# Access Compliance Report

## Public Rights-of-Way

### (Curb Ramps)

Intersection ID: N/A	Main Street: RICHFIELD_LN	Cross Street: N/A	Location: N
ADA ID: 7DE363FCD9DE	Ramp Type: Perp	Initial Pass/Fail: Fail	Overall Compliance: No
		Severity Score: 12.5

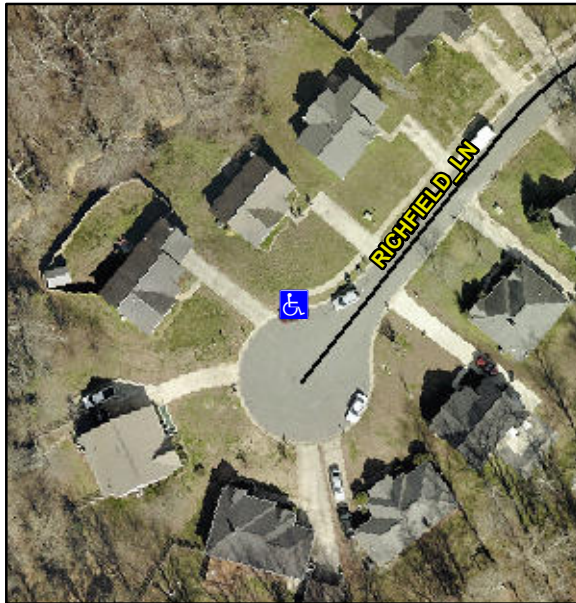
**Not Found, R304.2.2**

Compliance	Description	Data	Compliance	Description	Data
N/A	Ramp Length (in)	<b>48.0</b>	No	Ramp Slope (%)	<b>9.9</b>
Yes	Ramp Width (in)	<b>48.0</b>	Yes	Ramp XSlope (%)	<b>2.0</b>
N/A	Flare Type LT	<b>N/A</b>	N/A	Flare Type RT	<b>N/A</b>
N/A	Flare Slope LT (%)	<b>N/A</b>	N/A	Flare Slope RT (%)	<b>N/A</b>
N/A	Flare Traversable LT?	<b>N/A</b>	N/A	Flare Traversable RT?	<b>N/A</b>
N/A	Landing Length (in)	<b>N/A</b>	N/A	DWS Provided?	<b>N/A</b>
N/A	Landing Width (in)	<b>N/A</b>	N/A	DWS Contrast?	<b>N/A</b>
N/A	Landing Slope (%)	<b>N/A</b>	N/A	DWS Length (in)	<b>N/A</b>
N/A	Landing X Slope (%)	<b>N/A</b>	N/A	DWS Full Width?	<b>N/A</b>
N/A	Landing Curb? (Y/N)	<b>N/A</b>	N/A	DWS Offset (in)	<b>N/A</b>
N/A	Shared Landing?	<b>N/A</b>			
N/A	Gutter Ponding?	<b>N/A</b>	N/A	Gutter Slope (%)	<b>N/A</b>
N/A	Gutter Lip Ht (in)	<b>N/A</b>	N/A	Gutter X Slope (%)	<b>N/A</b>
N/A	Painted X Walk1?	<b>No</b>	N/A	Painted X Walk2?	<b>N/A</b>

**Remove & Replace Entire Ramp.**
